SEWAGE DISPOSAL SYSTEM

MARYLAND STATE DEPARTMENT OF HEALTH

A Repair

SUBDIVISION Holiday Hills ROAD 10705 Vista Road LOT

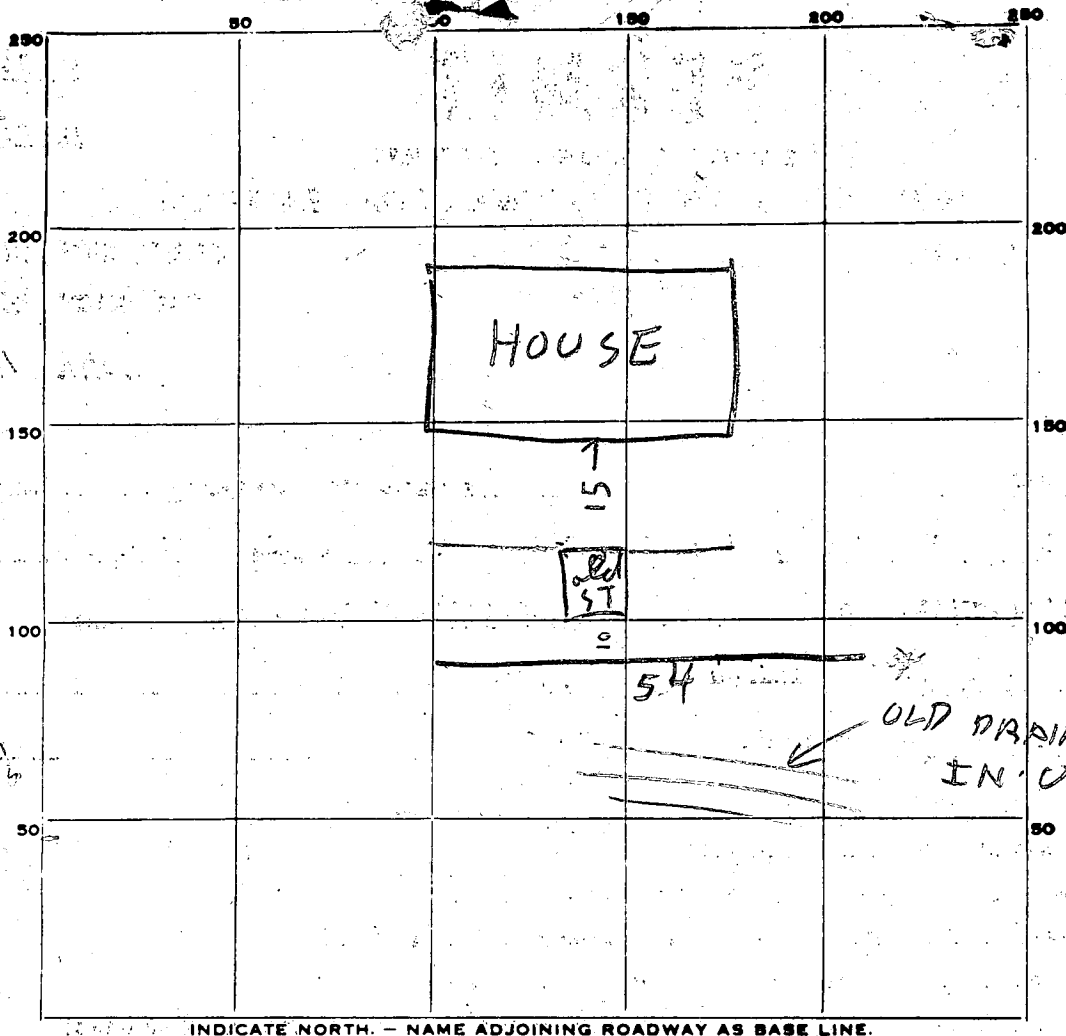
REPAIR - Call for an appointment when ground is opened up and Sanitarian will

recommend the repair system. PLACE DITCH BETWEEN OLD

SEPTIC TANK & VISTA RD ALONG LEVEL
GROUND

REMARKS 4/23/81 - DITCH DUG MOST OF DITCH 10 FT DEEP
BUT FAR END IS 14 FT DEEP ALL SAND & DRY
ADD STONE TO DITCH & REPLACE BROKEN TEE IN OLD TANK
4/23/81 1215 PM - STONE ADDED TEE REPLACED
WELL BEHIND HOUSE
